Lubecore Communication

Subject: Fitting Problem 21.113, 21.114, 21.229 and 21.230

Date: August 28, 2013

Picture of fittings showing proper and improper direction of ferrule before installation.

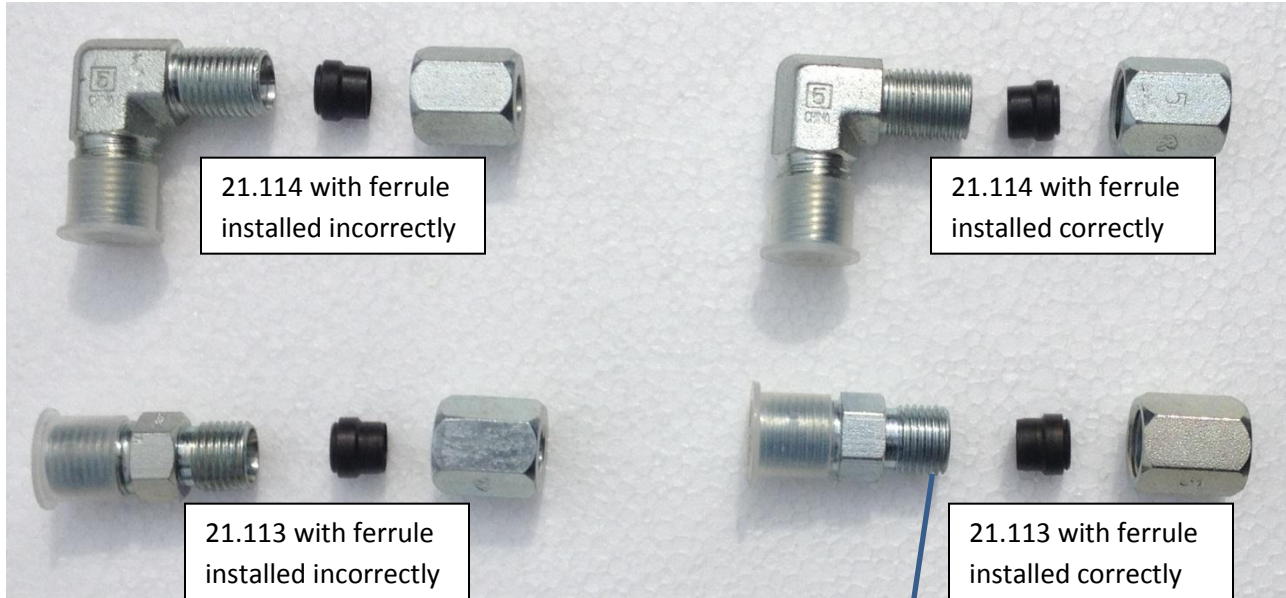
We have found that one of our suppliers has not been supplying our range of 8mm steel compression tube fittings: 21.113, 21.114, 21.229, 21.230 with the olive (ferrule) set properly. This has resulted in a few reported failures in the field. To immediately correct this issue, Lubecore will be addressing the concern with our supplier as well as checking all of our current inventory to ensure all product being shipped out is set in the fitting in the proper position.

1. For those whose shipment is in transit or who have not installed a pump system you have in stock – Take the nut off steel compression fitting and ensure that the olive is set in the fitting properly – see image below.
2. Before reassembling the fitting, we recommend that you lubricate the thread on the olive side – this will allow the compression to be completed with less effort.
3. Insert your tubing through the fitting and olive.
4. Use two wrenches to tighten the fitting until the olive is properly set.

Lubricate this thread before re-assembling.
This will allow the compression to be
completed with less effort.
